EXPERION PKS

RELEASE 510.1

Software Change Notice

EPDOC-X166-en-5101C

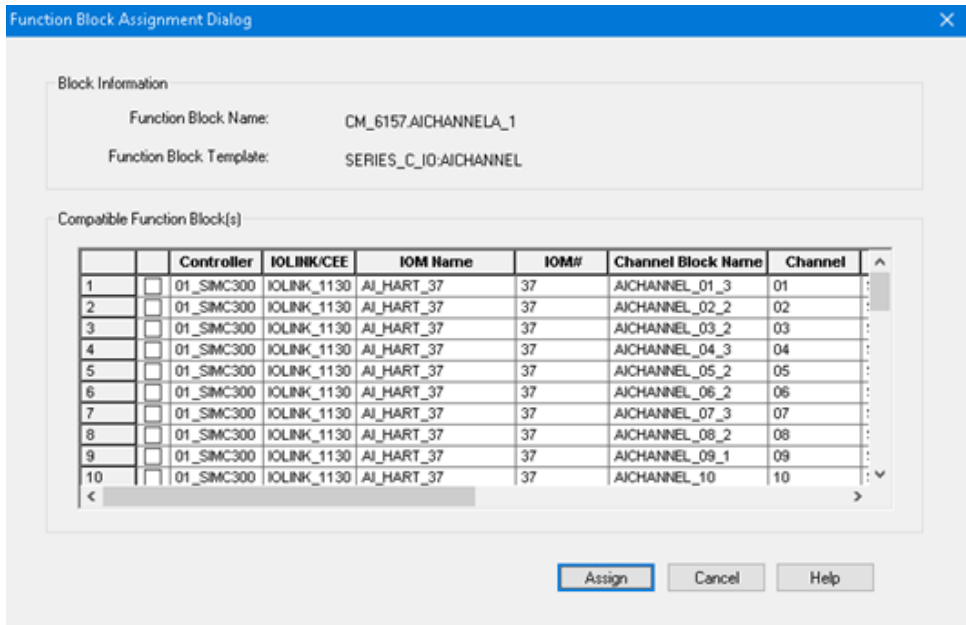
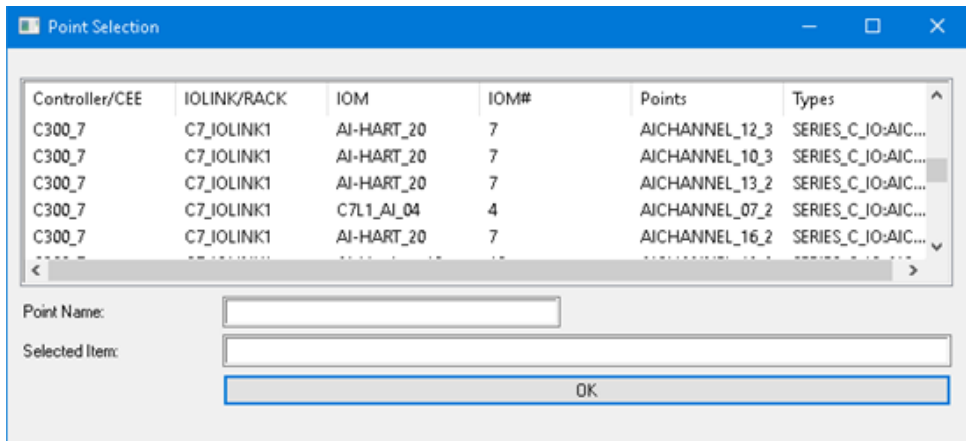
This feature displays additional information related to a channel so that the channel's hierarchy can be easily identified before assigning to a specific function block or an IO reference block.

Before the introduction of this functionality, the Function Block Assignment Dialog displayed:

With this enhancement, the following additional data is displayed in IO Reference Block Point Picker:

- C300 Controller Name
- IO Link Name
- IO Module Name
- IO Module Number

6.4.3 Modify override selector blocks to function like they do in HPM (UIS 2931)

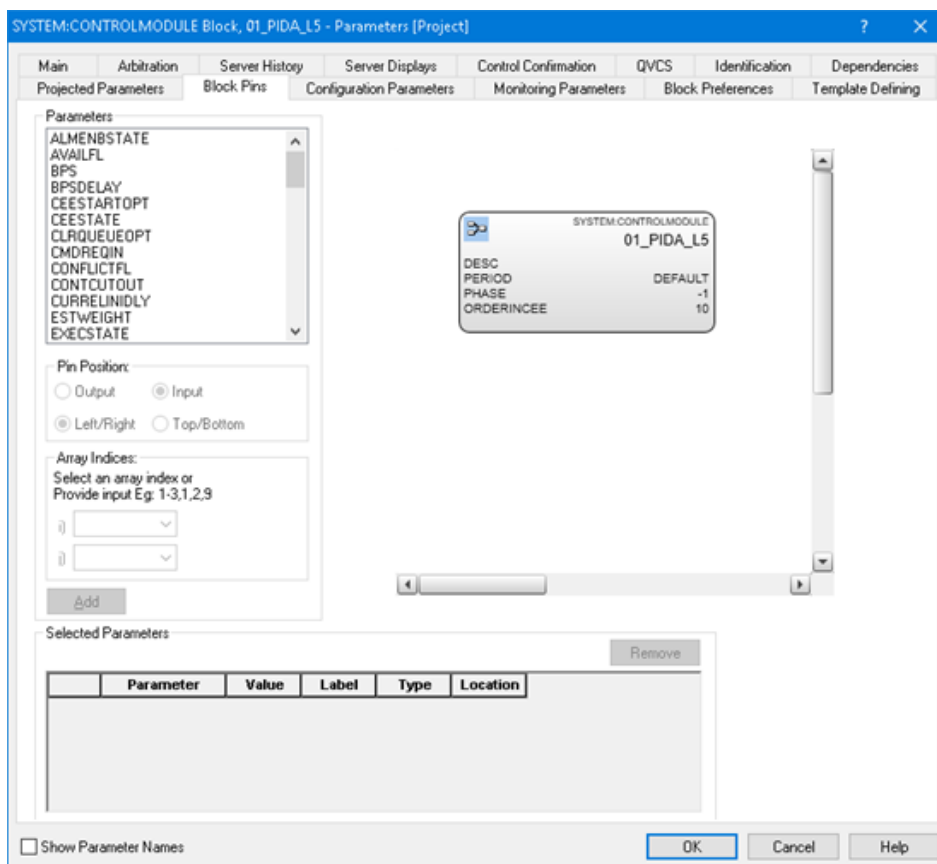
As part of this enhancement, the override selector block is modified so that it holds the last good value in its X1, X2, and so on input, on inactivation/reload of a primary. If this is the selected value, it will remain selected until another input moves to where it becomes selected. This would prevent plant shutdowns if a primary is reloaded without putting the override selector in MAN.

The Bad input option parameter can ignore, include and hold the last good input value by setting the parameter BADINPTOP[1..4]. This HoldOnBad parameter holds last good input value when an intializable input goes bad on inactivation or reload of a primary.

6.4.4 Library Blocks - Block Pins (UIS 4453)

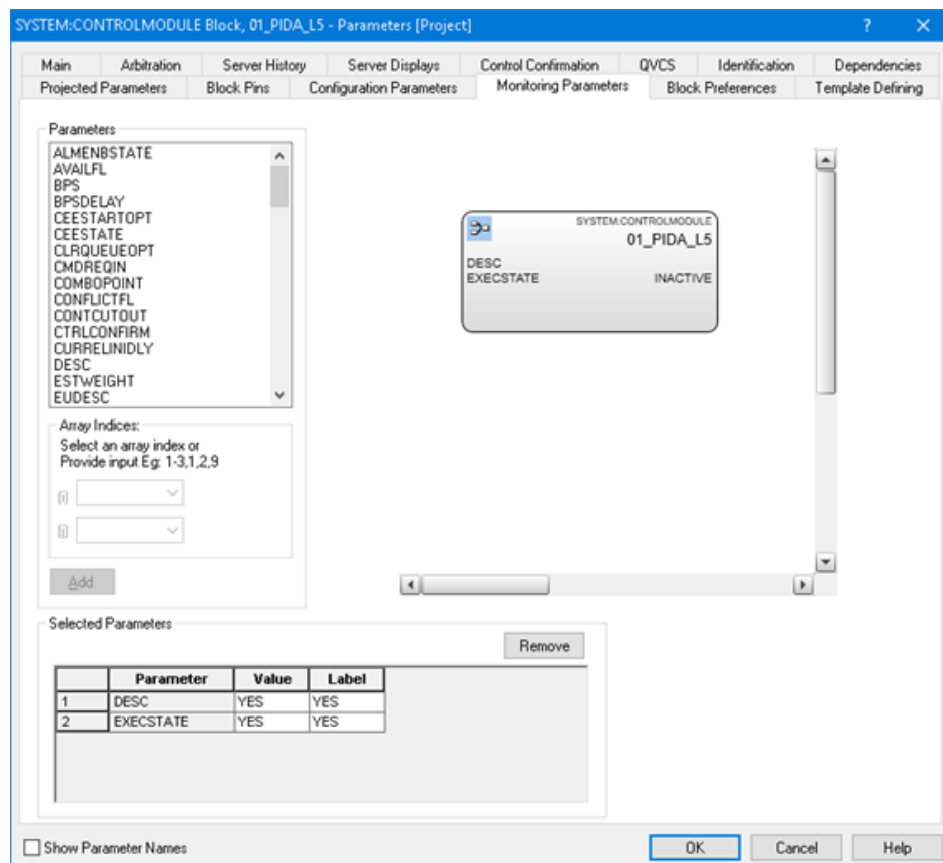
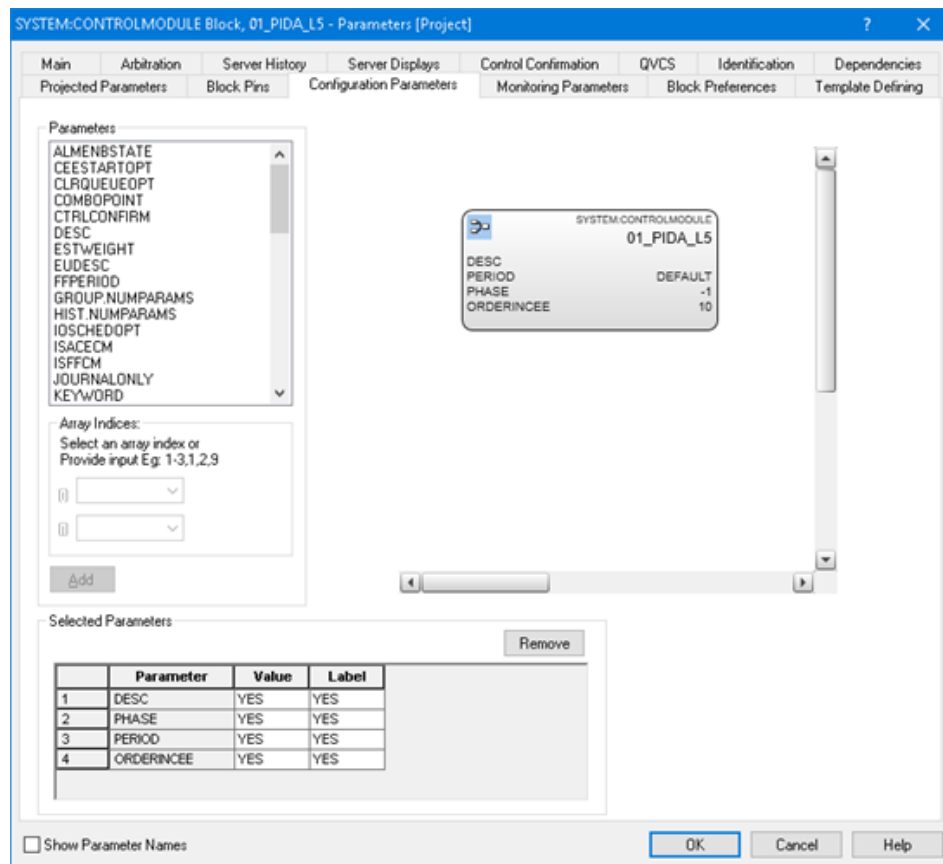
This enhancement applies to the Library Blocks - Block Pins. With this enhancement, you can perform the following operations:

- Add/remove multiple array indexes at a time using shift or control keys.
- For an arrayed parameter, you can either select a particular index or provide input similar to a printing page.

Figure 6.1 SmartLine Point Detail Display with Overview sub-display

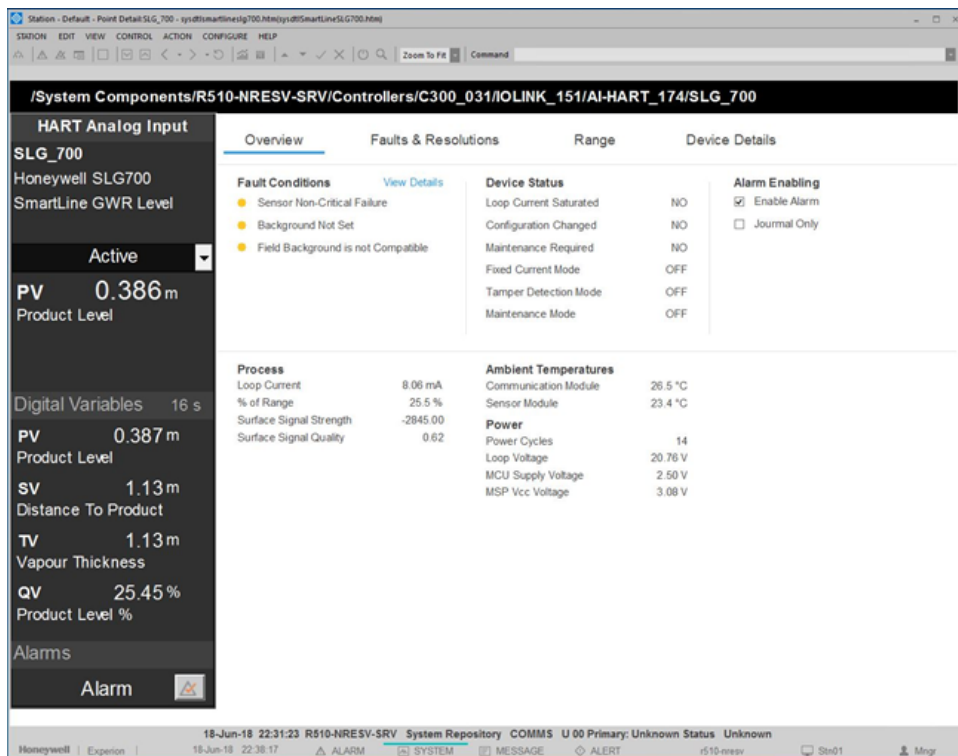
The optional point detail displays and faceplates designed specifically for Honeywell SmartLine transmitters, first introduced in Experion R510, have been enhanced with device specific information. These new displays and faceplates were designed and implemented based on Honeywell User Experience (HUE) principles. The goal is to deliver the best user experience through modern visual design, simple navigation and intuitive arrangement of information, such that plant operators and maintenance technicians can access important process, configuration and diagnostic information of the SmartLine transmitters easily and perform any necessary actions promptly.

As shown in the figure below, the new SmartLine point detail display follows a similar layout as the existing generic point detail display for an analog channel:

As shown above, the SmartLine faceplate on the left-hand side of the display provides information about the type of SmartLine transmitter the analog input channel is connected to. In addition to displaying the values of the analog PV calculated by the I/O module and the HART digital dynamic variables (PV, SV, TV and QV), the SmartLine faceplate has been enhanced to show the engineering units and descriptions of these variables. The faceplate continues to provide a means to acknowledge active alarms of the analog input point and a link to the control module's point detail display if the analog input point is associated with a control module.

The Overview sub-display is the default sub-display on the initial load of the SmartLine point detail display. This sub-display is intended to provide a quick overview of the critical information about the SmartLine transmitter right at the first glance. The top portion of the Overview sub-display has three sections: Fault Conditions, Device Status and Alarm Enabling. The Fault Conditions section displays the active fault conditions reported by the SmartLine transmitter or the analog input module. An active fault condition is shown as a line item with a round priority indicator and a text string to describe the fault condition. The color of the round indicator shows the priority of the fault condition: red for critical condition and yellow for non-critical condition. A maximum of six active fault conditions can be shown in the descending order of priority. When there are more than six active fault conditions, only the six conditions of the highest priorities are shown. To view all the active fault conditions, the user can click the View Details hyperlink at the top right corner of the Fault Conditions section to navigate to the Faults & Resolutions sub-display. When there is no active fault condition, the Fault Conditions section shows one line item with a gray round status indicator and a text string of "No fault conditions", and hides the View Details hyperlink.

Figure 6.2 SmartLine Point Detail Display with Faults & Resolutions sub-display

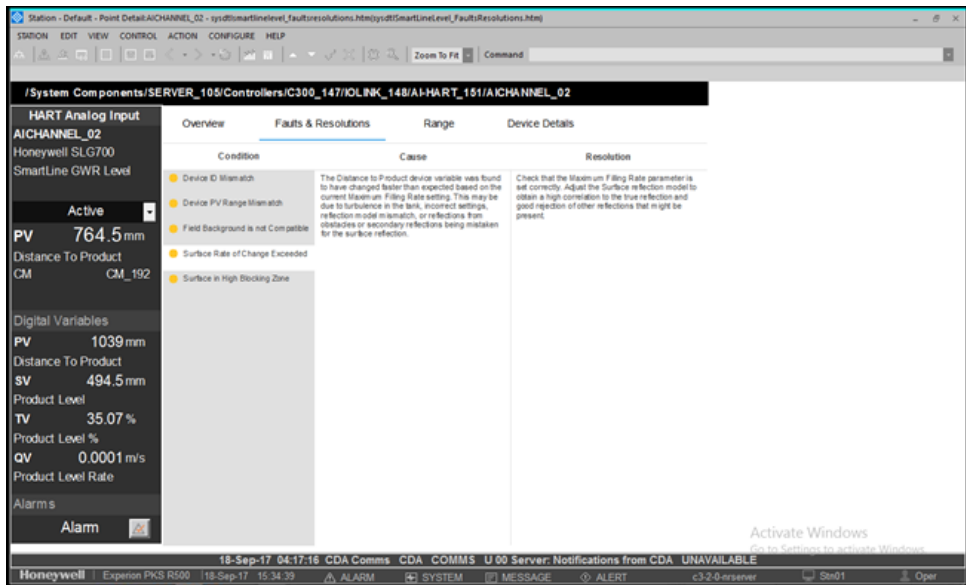
The following image shows the Faults & Resolutions sub-display of the SmartLine point detail display. As mentioned previously, in addition to clicking the Faults & Resolutions navigation button, the user can navigate to the Faults & Resolutions sub-display from the Overview sub-display by clicking the View Details hyperlink in the Fault Conditions section if there are active fault conditions.

The Faults & Resolutions sub-display provides quick and easy access to potential cause and resolution information for the active fault conditions of the SmartLine transmitter, and facilitates the process of troubleshooting the fault conditions. The sub-display is divided into three vertical sections: Condition, Cause and Resolution. The Condition section displays up to 14 active fault conditions for the SmartLine transmitter and associated I/O module. An active fault condition is shown with a round priority indicator; red for critical conditions and yellow for non-critical conditions. The list is sorted so that all critical conditions are at the top. If more than 14 fault conditions are active, “Prev” and “Next” buttons will appear at the base of the section to allow the user to review all active fault conditions.

Figure 6.4 SmartLine Point Detail Display with Device Details sub-display

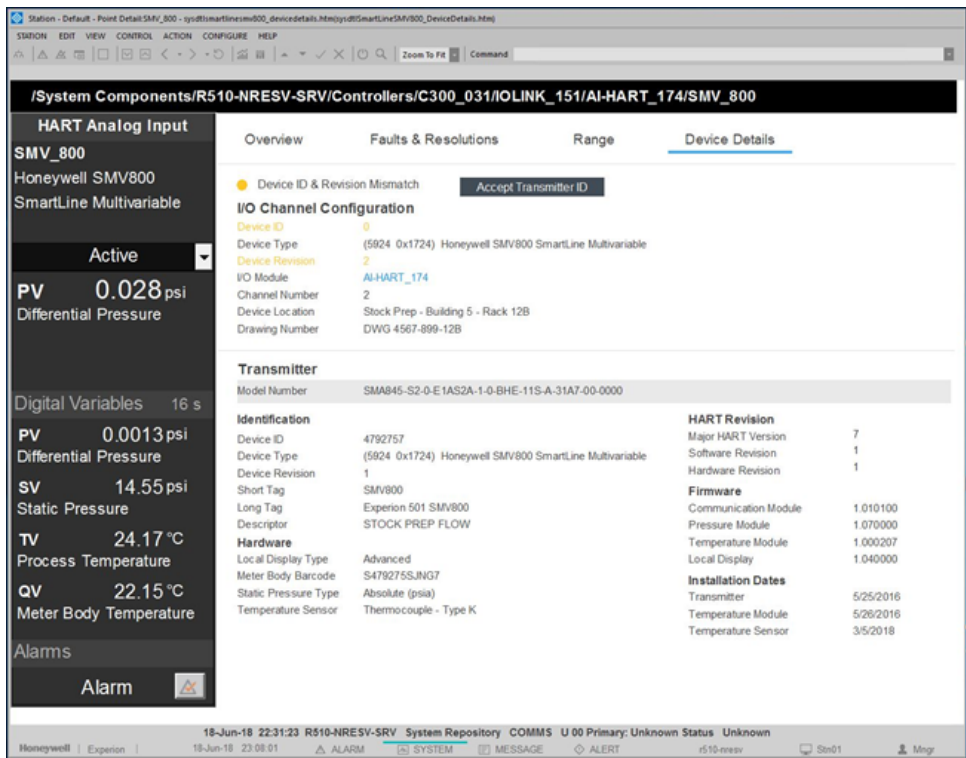
The following image shows the Device Details sub-display of the SmartLine point detail display, which is divided into two top and bottom sections: I/O Channel and Transmitter. The I/O Channel section shows identification information about the transmitter taken from the configuration within the Experion I/O module. The Transmitter section shows identification information about the SmartLine transmitter read directly from the transmitter. This includes information that is common to all HART transmitters as well as hardware information that is specific to each type of SmartLine transmitter.

The 3 common parameters that appear in each section, Device Type, Device ID and Device Revision, are generally expected to have the same values. If either of these are different between the I/O channel configuration and the physical transmitter, the I/O module will report an appropriate fault condition. If present, these fault conditions are reported above the I/O Channel section. The display provides a convenient one-click means to resolve conflicts in the Device ID parameter. Conflicts in the Device Type or Device Revision parameters, however, must be resolved through the Control Builder application.
